Meeting Agenda

Franklin Municipal Planning Commission

Thursday, December 10, 2020

DEVELOPMENT
PLAN
SHEET
C2.0
COF 7375

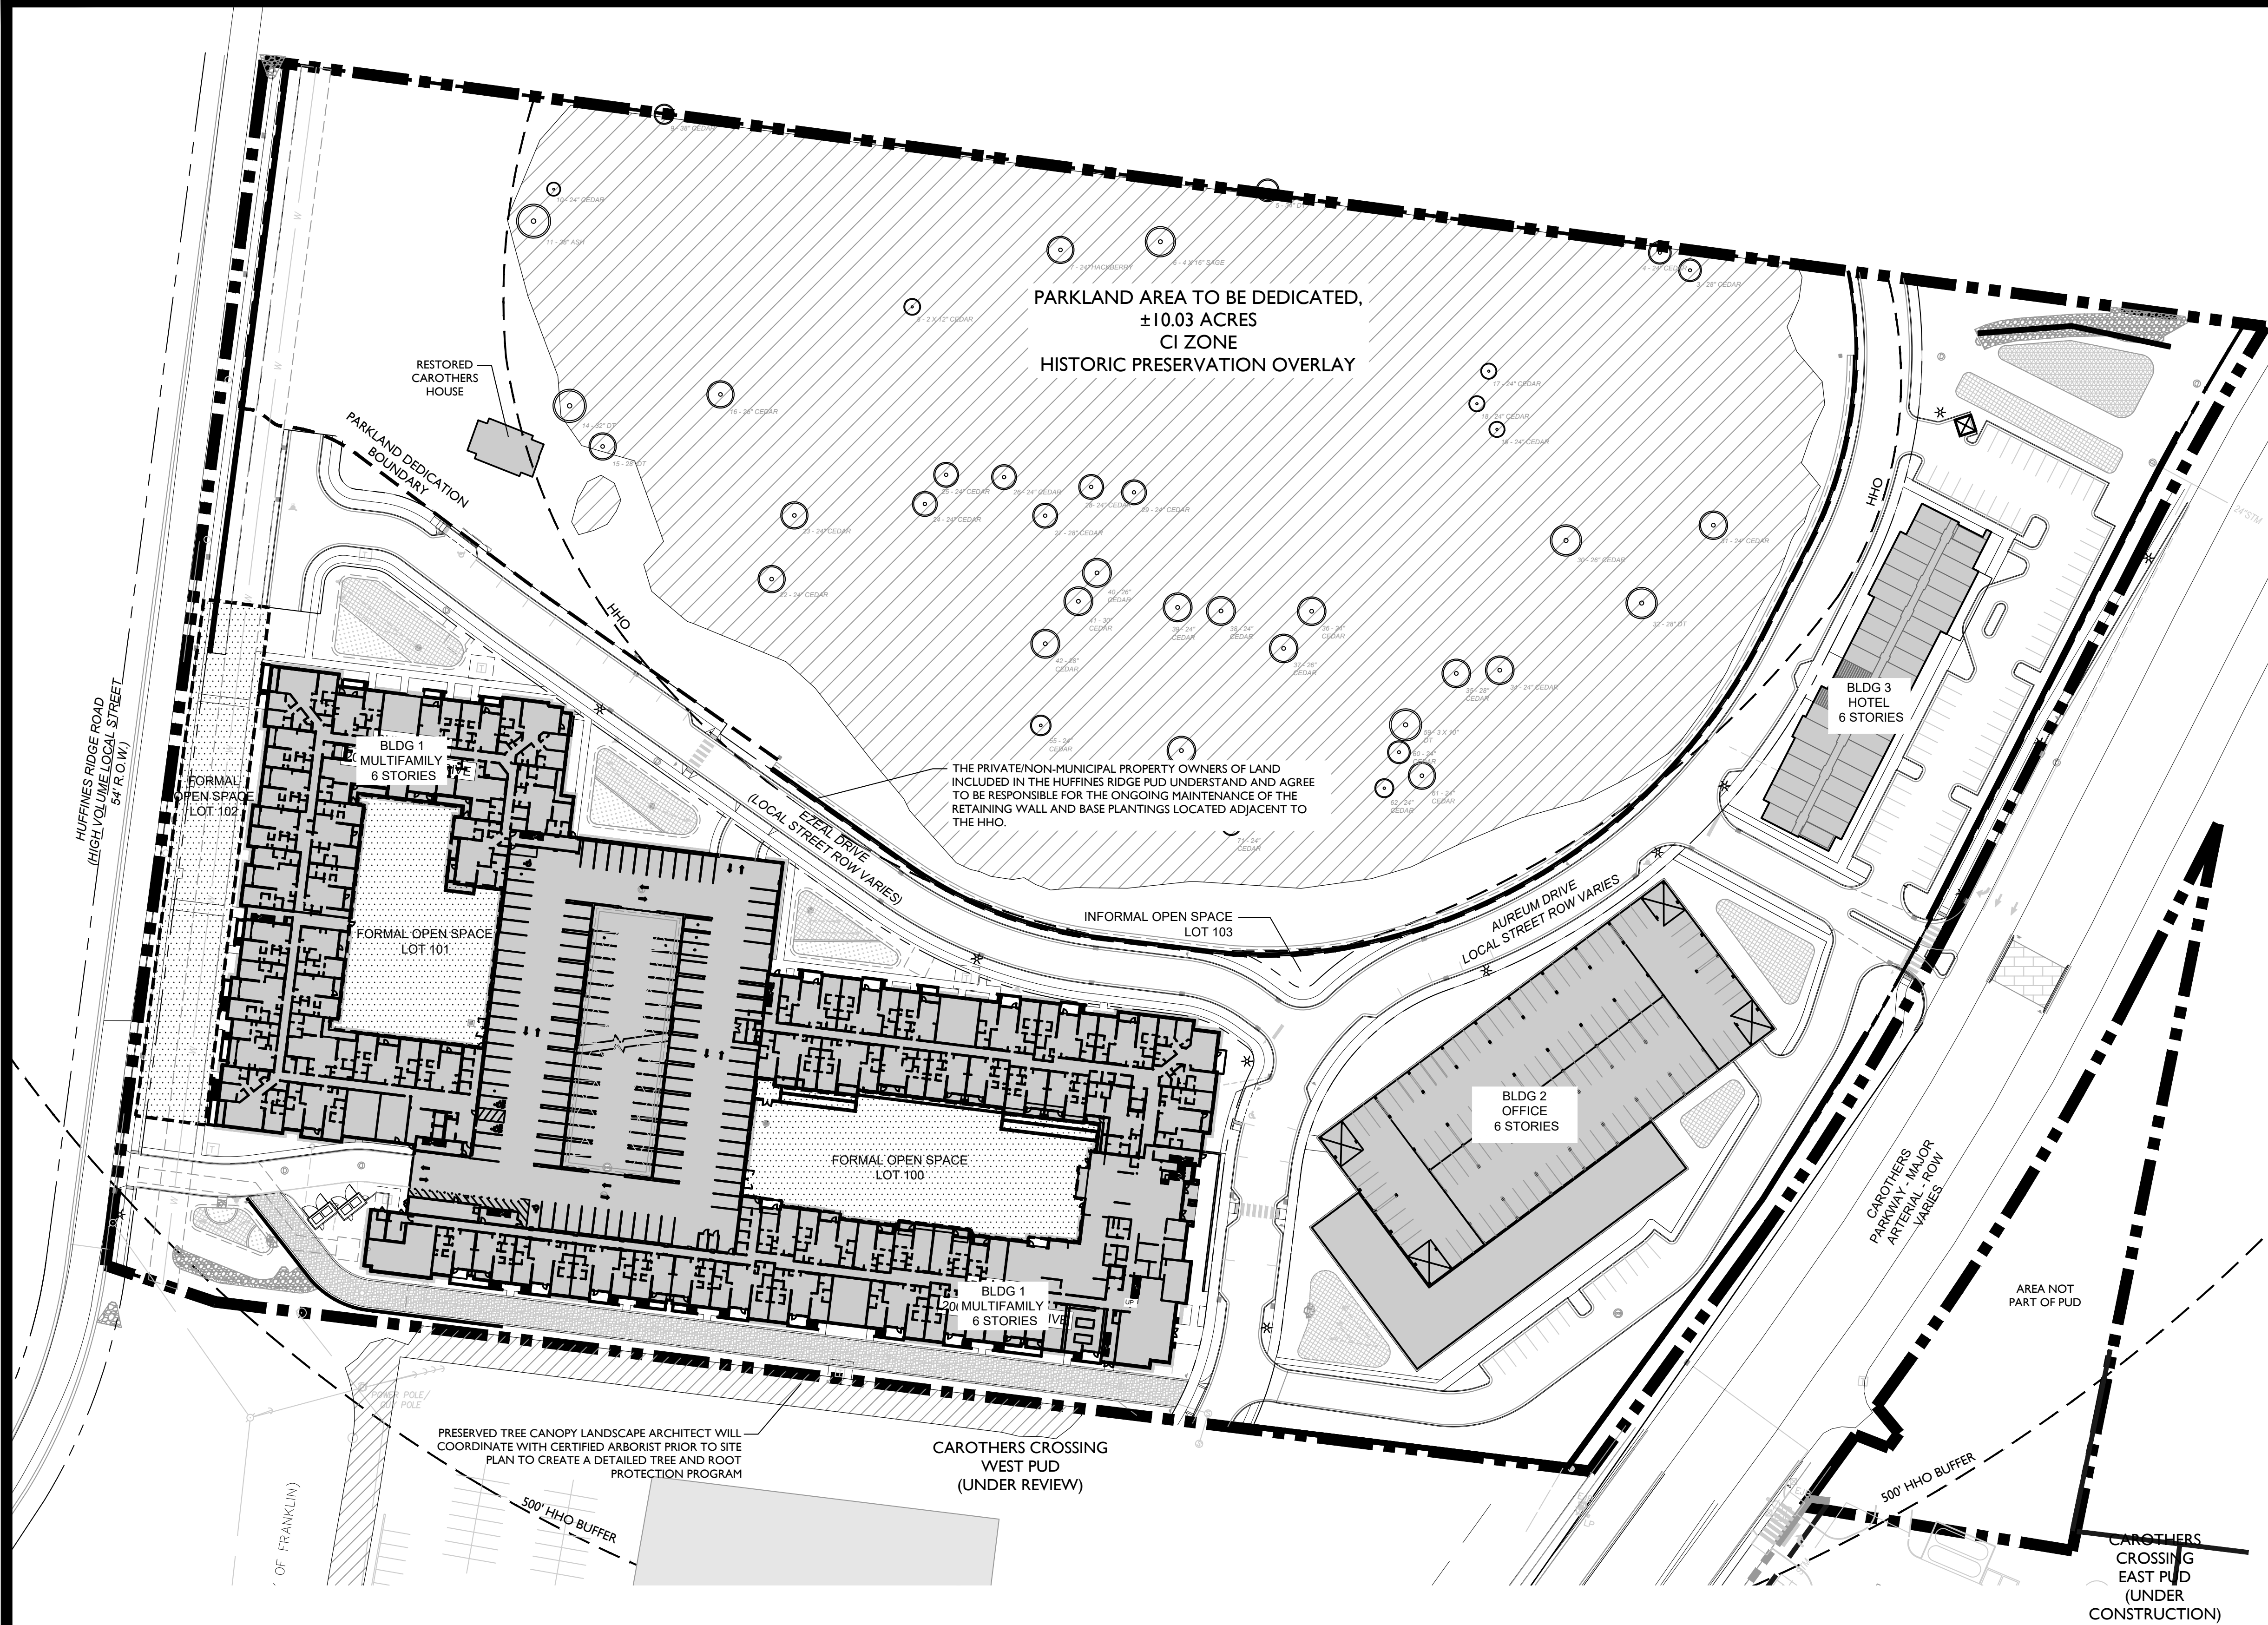
24. parking table/agreement

Comment not addressed. The parking table/agreement from the original development plan shall be included on this revision, on sheet C2.0:

Per the BCMA approved condition of approval, Phase I of the multifamily use will not proceed until one of the following conditions satisfies parking requirements:

Comment not fully addressed. The HPO is listed on the site, on sheet C2.0, but shall also be included on the Site Data Chart.
